**Record of Decision  
and  
Finding of No Significant Impact  
for  
Big Arm State Park Major Maintenance Project**

March 16, 2005

# APPENDIX C

## Alternative 2 (modified)

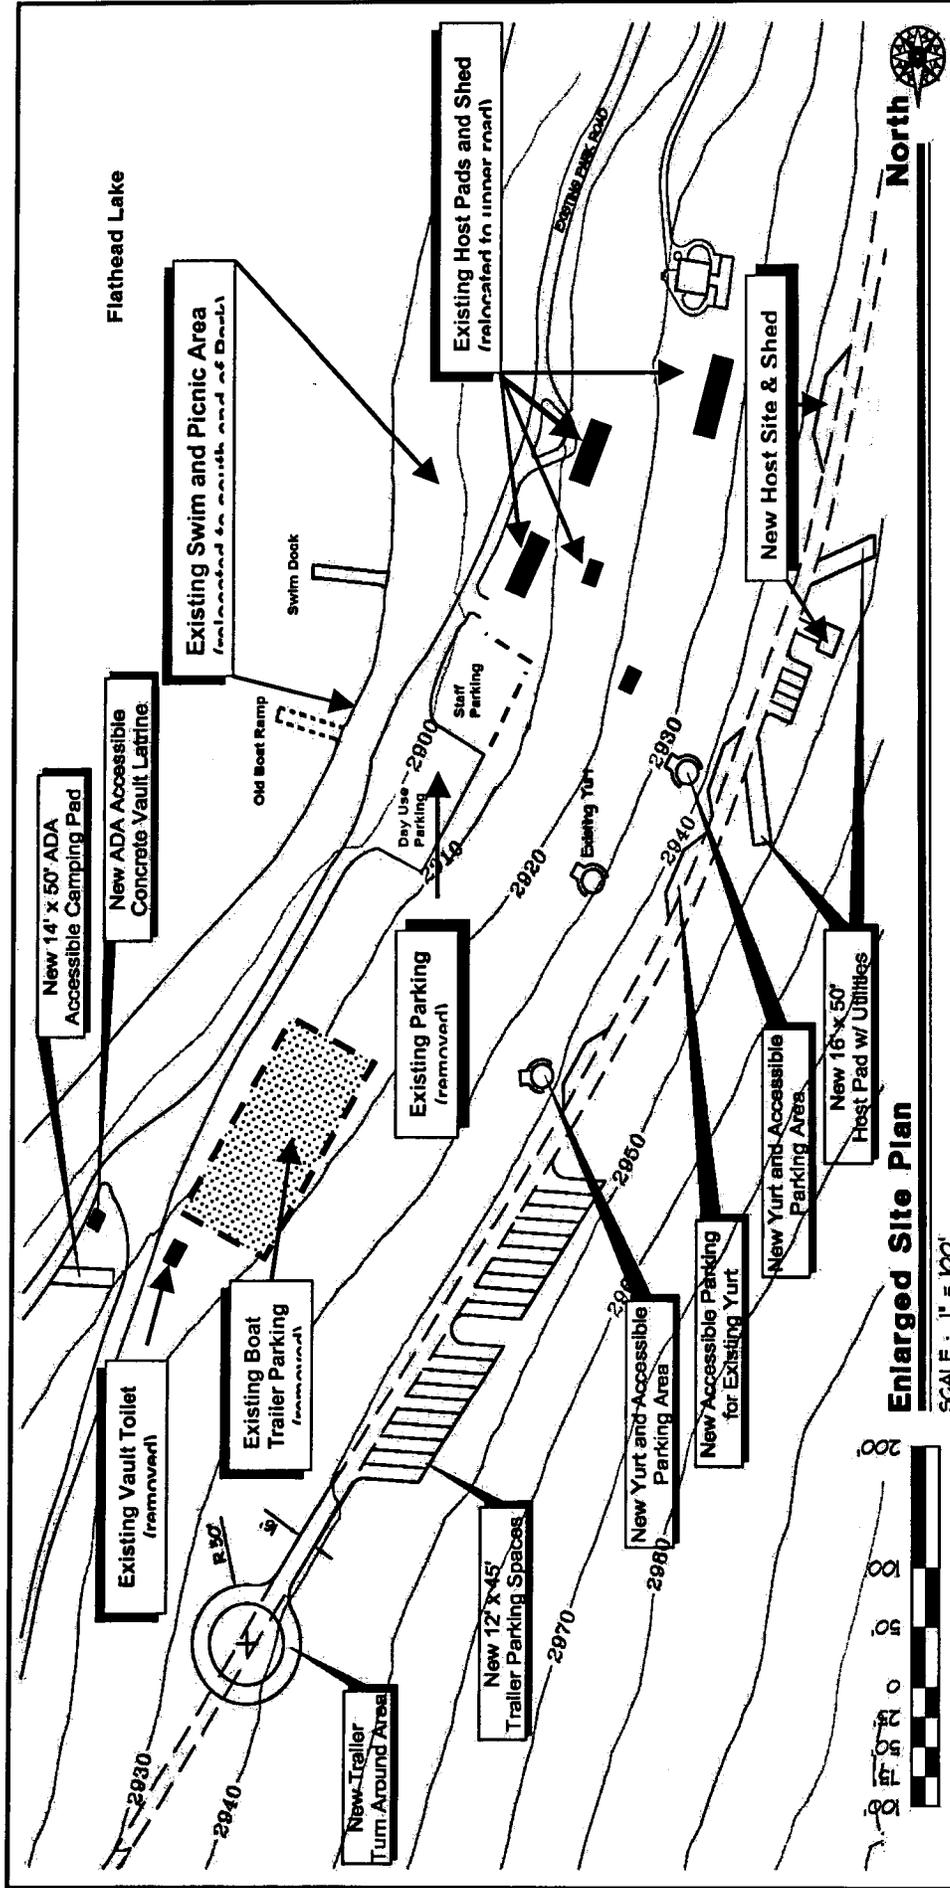
- Moving of day-use swim area to the south end of the park will decrease size of the day-use picnic area.  
The area of the relocation is actually slightly larger than the current site. No loss of acreage will occur.

- Insufficient shade available at the south end of the park at the proposed new swim area.  
Shading is reduced at the south end of the park. This can be mitigated by planting trees for the future and incorporating shade structures over the picnic tables in the interim.

- Reduction of access to the lake by moving the swim area.  
No reduction of access to the lake will occur. The proposed location is currently minimally utilized. This is simply a relocation to reduce crowding and enhance safety.

- Additional costs involved with relocating host pads and visibility.  
The costs of relocating the host pads does not involve adding a lift station, and existing power and water lines are near to the new proposed locations, which will significantly minimize costs. Placing pads upslope, with vegetative screening, does not restrict access by visitors. Visual or aesthetic considerations in park areas is an important element in park management, and efforts to reduce clutter and maintain the naturalness of these areas is part of the state parks legislative mandate.

Based on the analysis in the environmental assessment (EA), I find Alternative 2, with modification (see modified Appendix C, Alternative 2, attached), to be the preferred alternative. The modification entails relocating all three host pads to the upper road versus having one host pad along the campground entrance road. This alternative will meet the objectives of reduced campground traffic and improved utilization of park areas and resources. The alternative will also relocate camper boat trailer parking to the upper

road and relocate the swimming and day-use area to the south end of the park to improve safety and reduce crowding. Additionally, it will restore some areas to a more natural condition and enhance the visual characteristics of the campground.
